## 10.4 Other Features of Steam and Power Conversion

The information in this section of the reference ABWR DCD, including all subsections, tables, and figures is incorporated by reference with the following departures and supplements.

### Figure 10.4-5 Condensate System

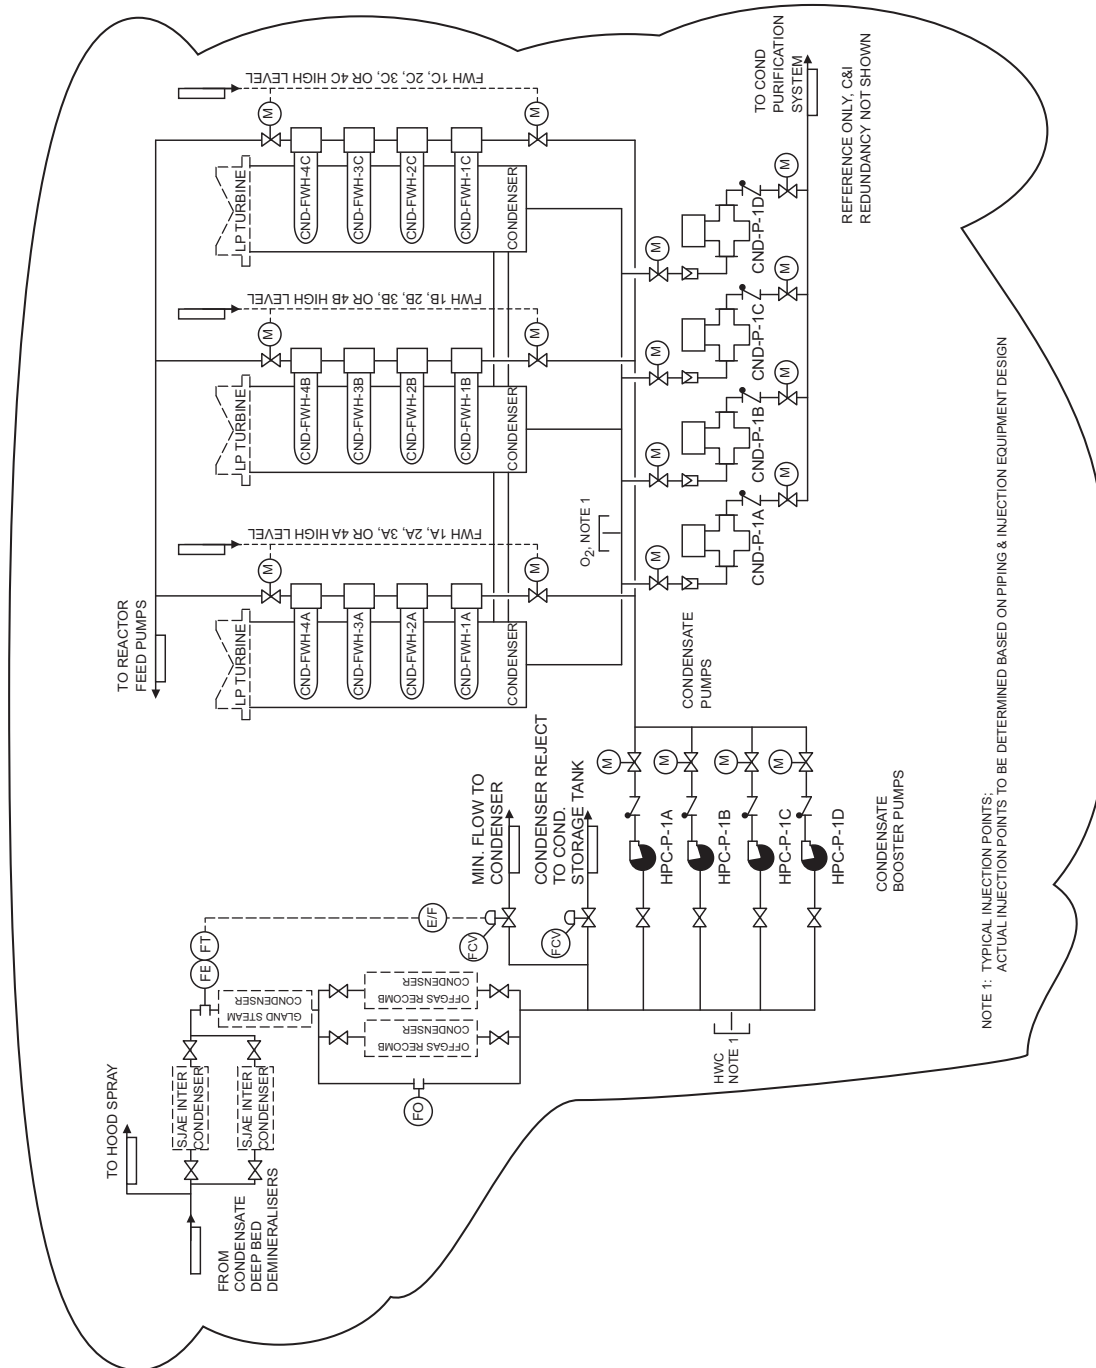
STP DEP 10.4-5 (Table 10.4-5, Table 10.4-6, Figures 10.4-5, 10.4-6, 10.4-7, 10.4-8)

*The CFS consists of four ~~33-50%~~ 33% capacity condensate pumps (three normally operating and one on automatic standby), four 33% capacity condensate booster pumps, (three normally operating and one on automatic standby), ~~three normally operated 33-65%~~ four 33% capacity reactor feedwater pumps (three normally operating, one on automatic standby), four stages of low-pressure feedwater heaters, and two stages of high- pressure feedwater heaters, piping, valves, and instrumentation. The condensate pumps take suction from the condenser hotwell and discharge the deaerated condensate into one common header which feeds the condensate filter/demineralizers.*

*Downstream of the condensate demineralizers, the condensate is taken by a single header and flows ~~in parallel through five~~ through the auxiliary condenser/coolers, (one gland steam exhauster condenser, ~~and two sets of~~ two sets of SJAЕ condensers, ~~and two sets of~~ offgas recombiner condenser (coolers). The condensate then branches into three parallel strings of low pressure feedwater heaters. Each string contains four stages of low-pressure feedwater heaters. The strings join together at a common header which is routed to the suction of the reactor feedwater pumps.*

Figure 10.4-9 Bypass Valve Control, Electro-Hydraulic Control Unit

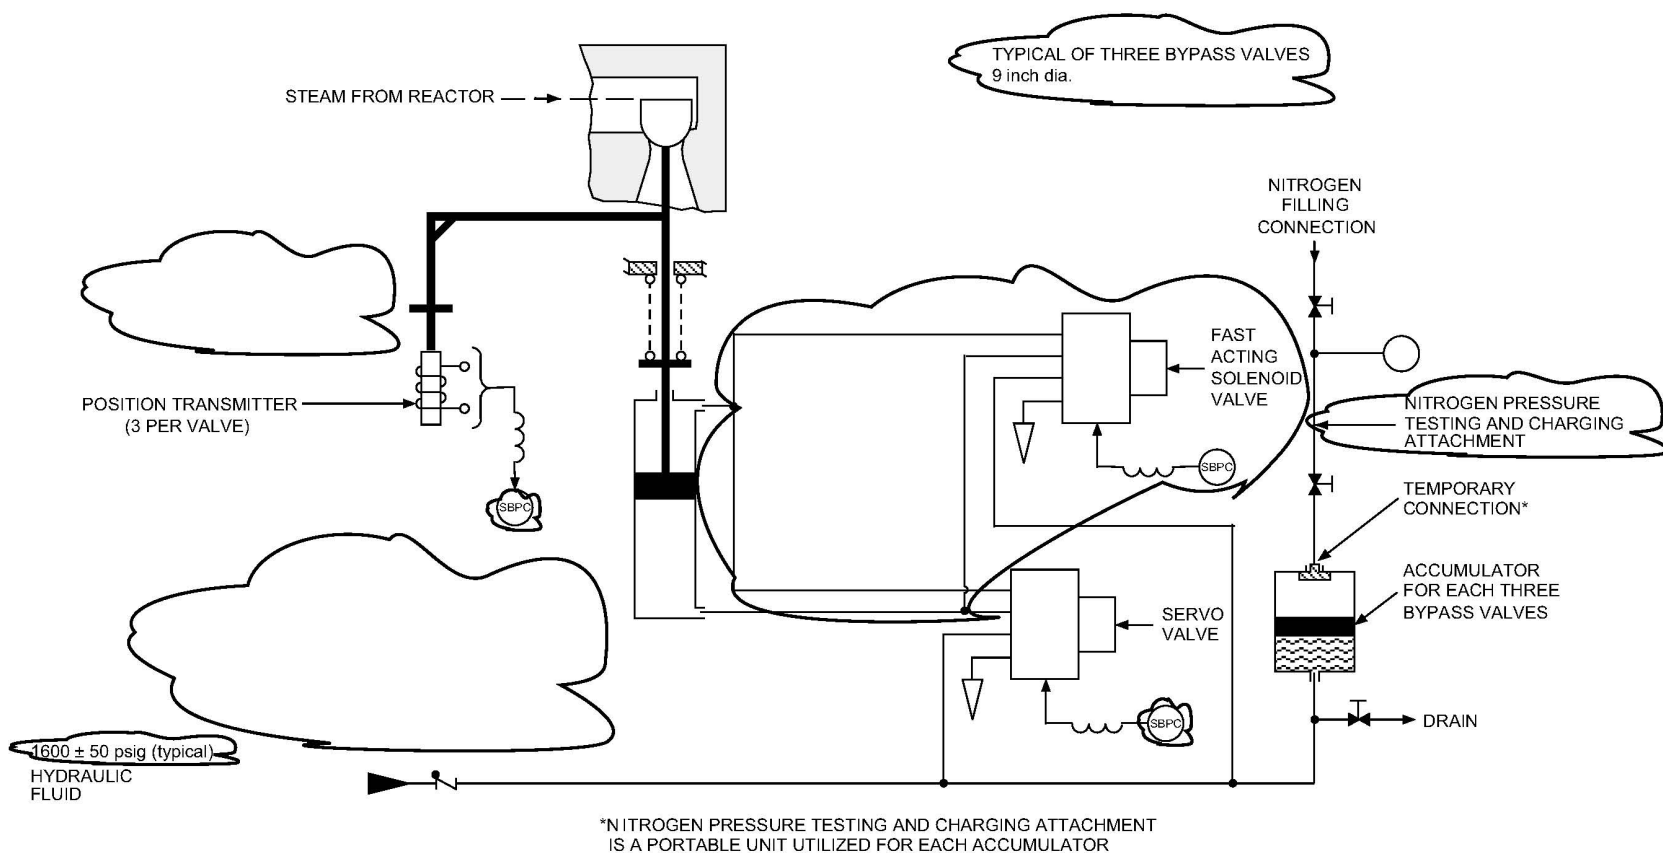
STD DEP 10.4-7 (Figure 10.4-9)
